Jacksons Row - changes

Jacksons Row Elevation - Consented

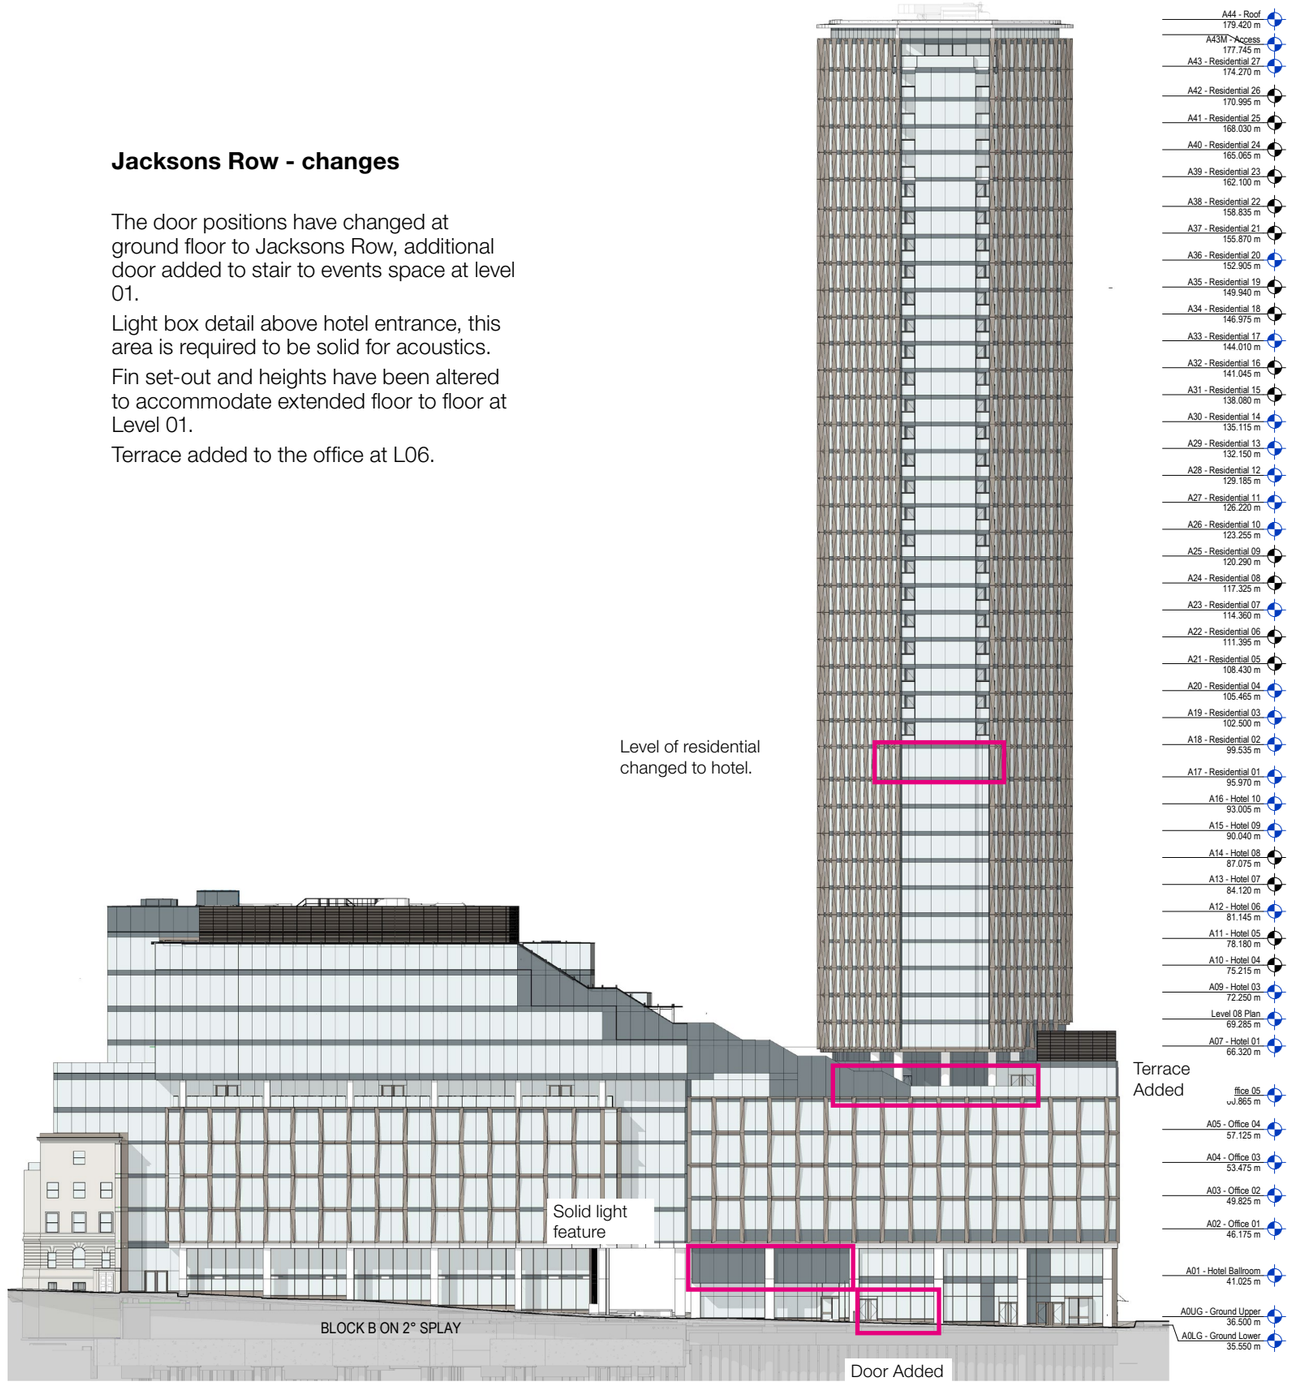
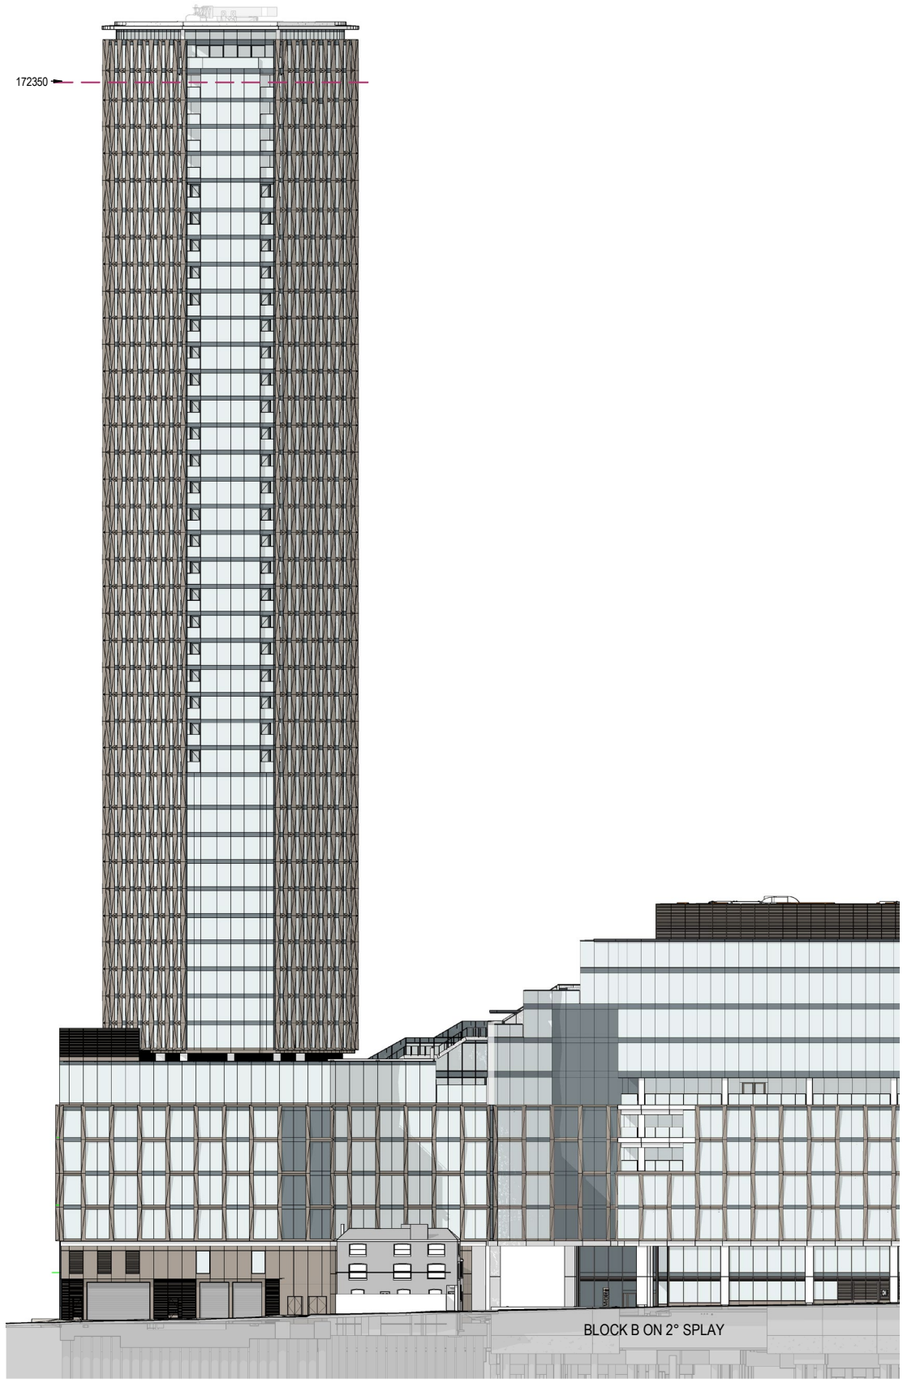
The door positions have changed at ground floor to Jacksons Row, additional door added to stair to events space at level 01.

Light box detail above hotel entrance, this area is required to be solid for acoustics.

Fin set-out and heights have been altered to accommodate extended floor to floor at Level 01.

Terrace added to the office at L06.

Bootle Street Elevation - Proposed

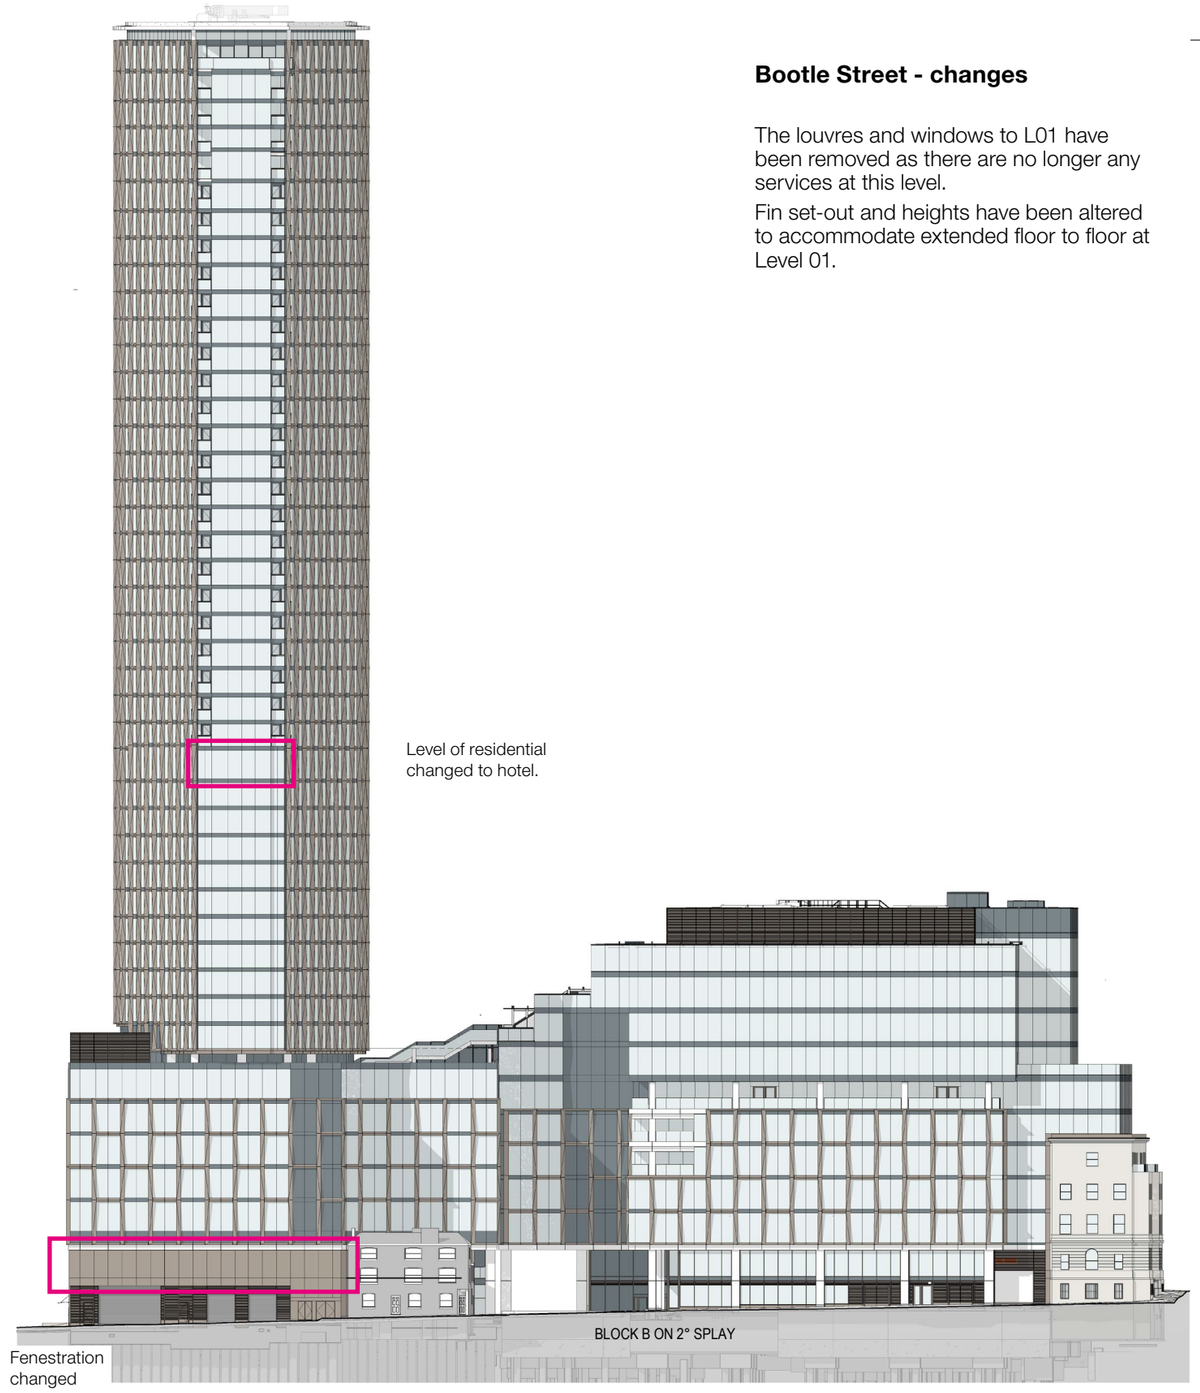
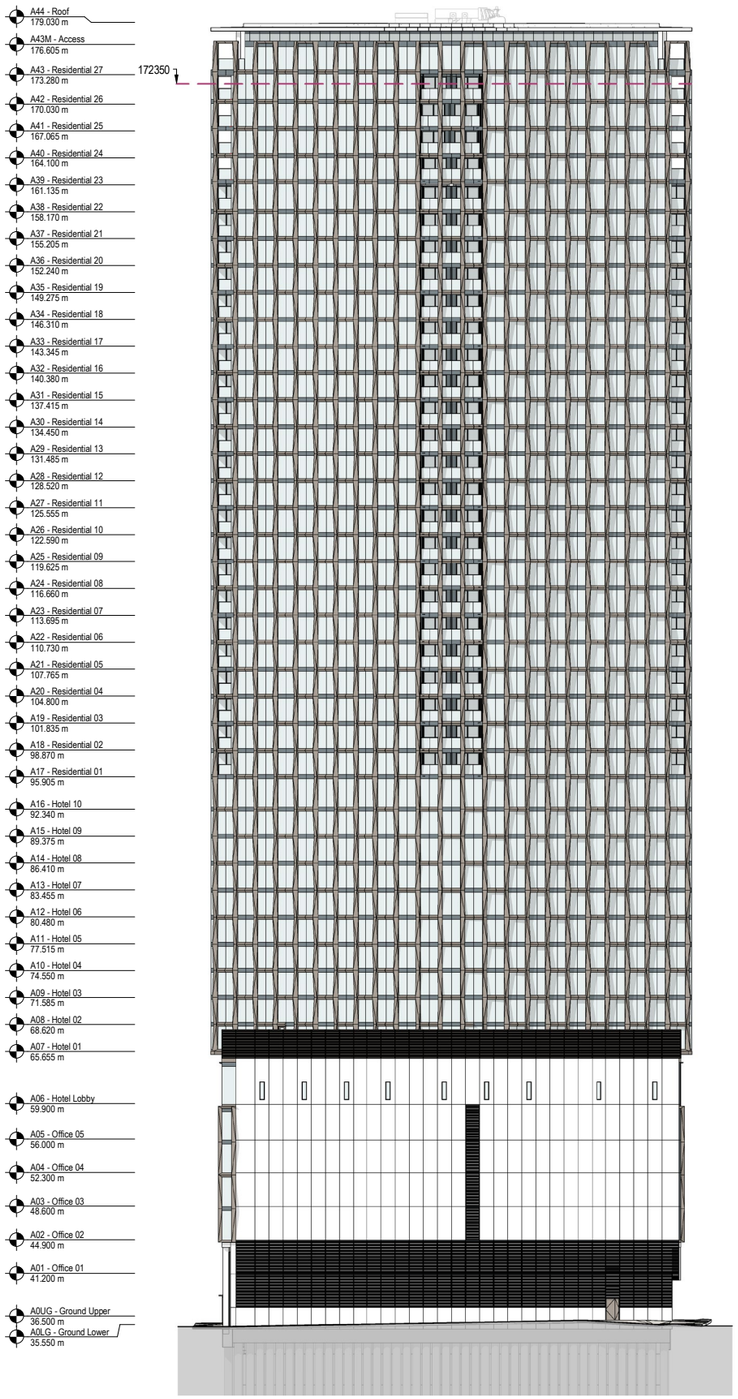
The louvres and windows to L01 have been removed as there are no longer any services at this level.

Fin set-out and heights have been altered to accommodate extended floor to floor at Level 01.

West Elevation - Proposed

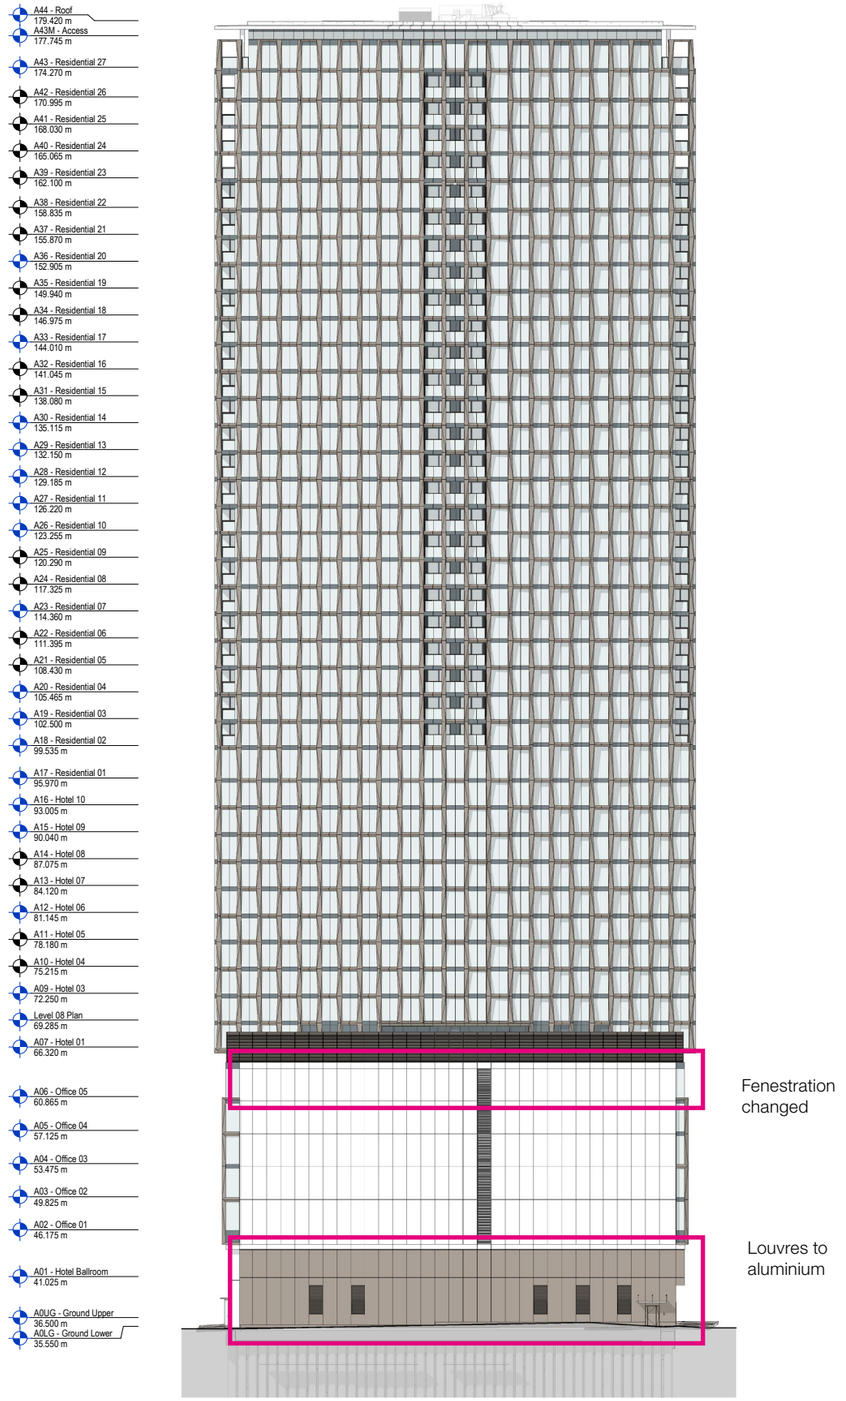
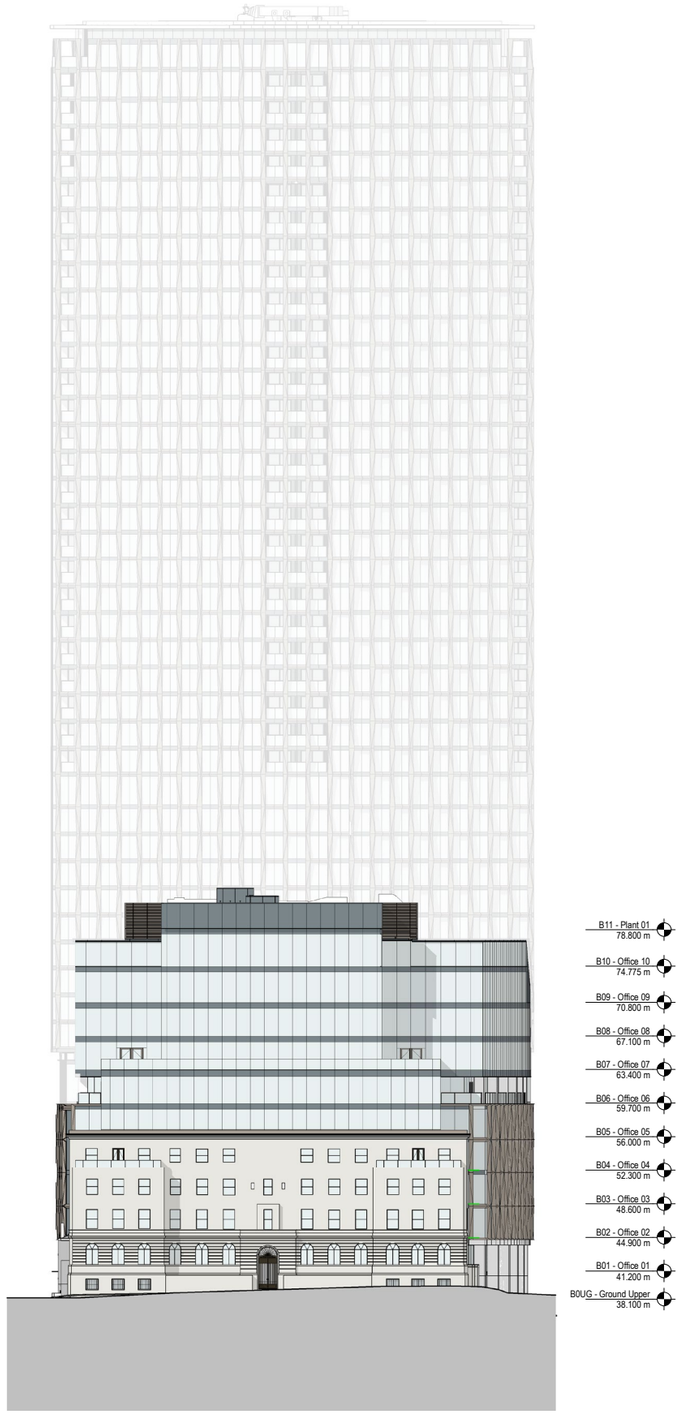
The windows have been removed to L06

The Lourve composition and setout has been changed to match amended MEP.

Finish to wall to has been changed to aluminium plinth and render above to match No.1

Block A Courtyard Elevation - Proposed

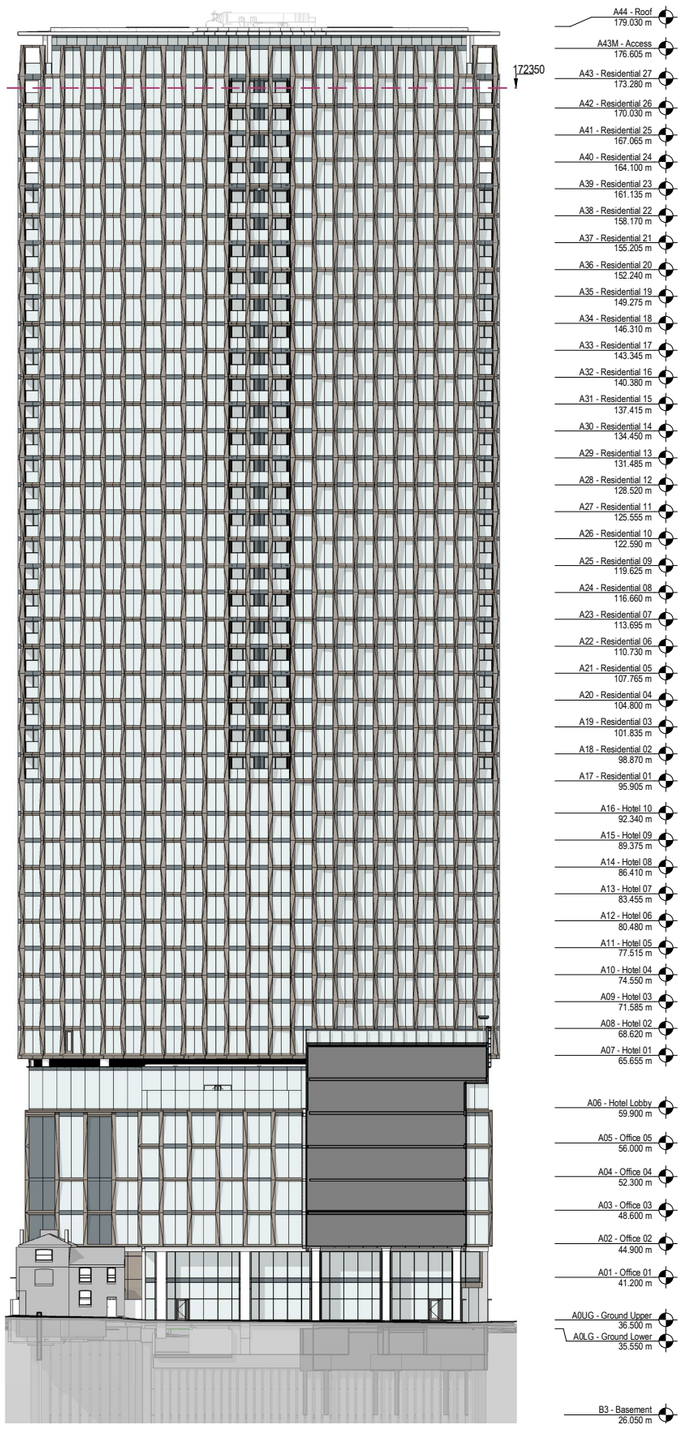
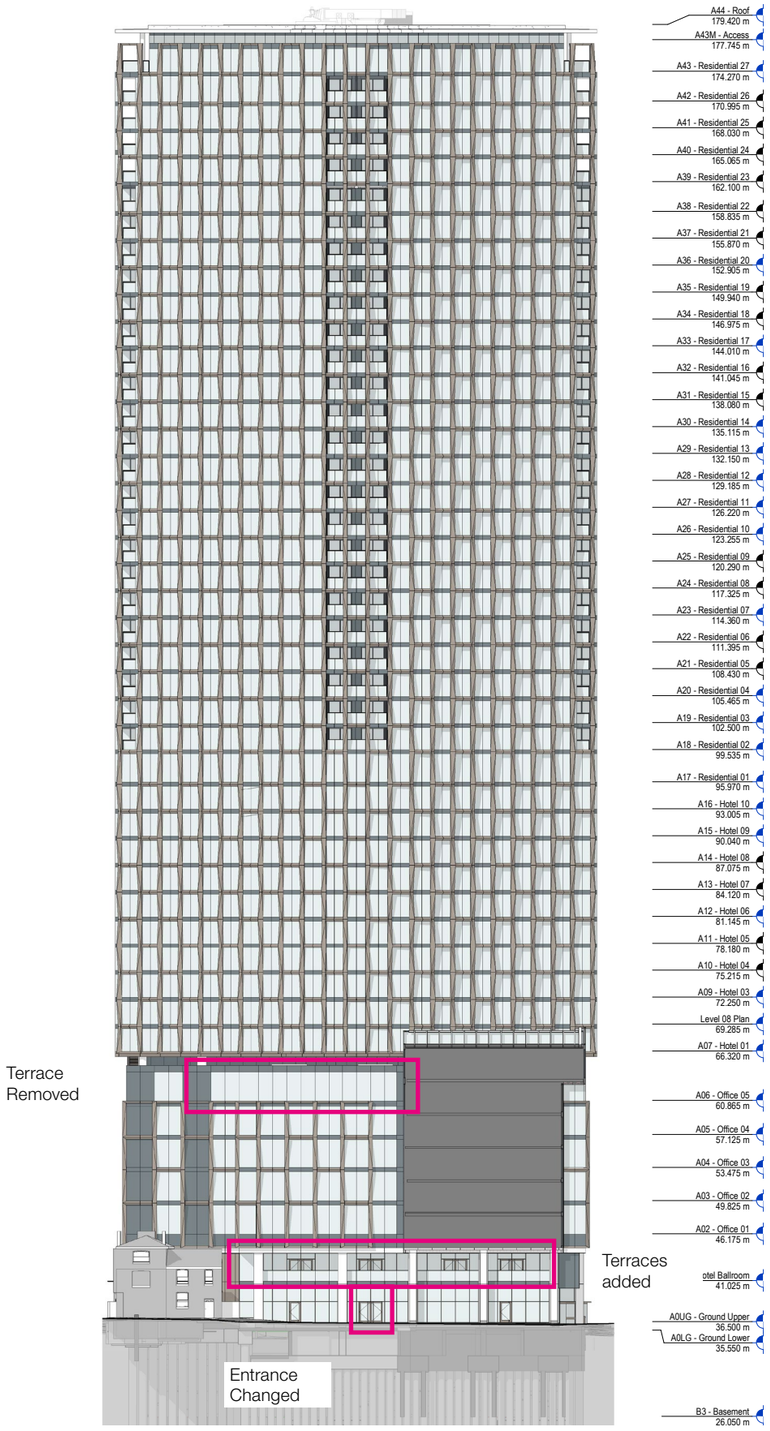
The terrace has been removed to Level 06 and moved to Jacksons Row elevation.

The facade has been pulled out at ground level and used to form a series of balconies to the Level 01 events space.

Fin set-out and heights have been altered to accommodate extended floor to floor at Level 01.

Block B Terraces Elevation - Proposed

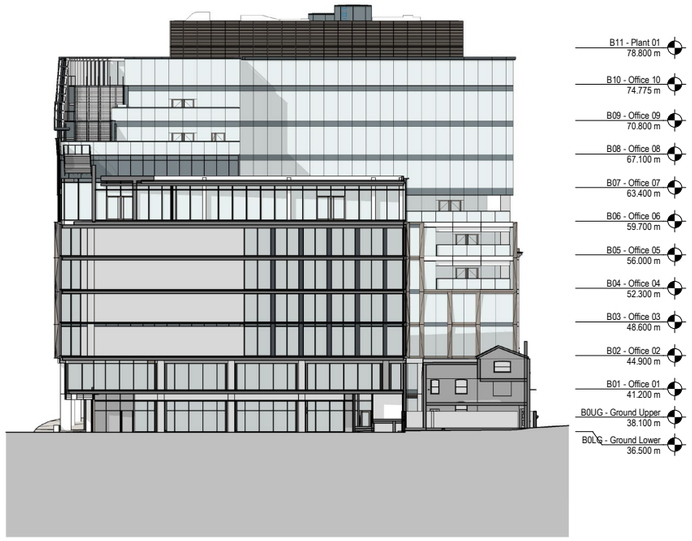
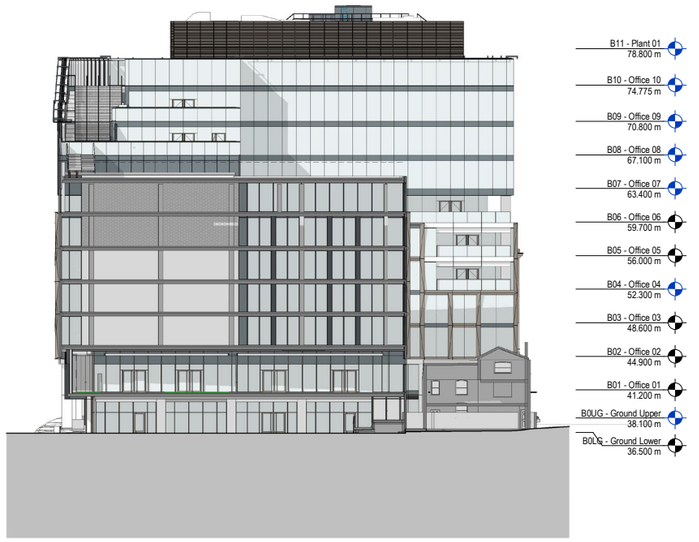
The tower height has increased by 390mm due to development of the design and structure and to maintain buildability.

The balconies now start a floor later as a floor of residential us has been changed to hotel.
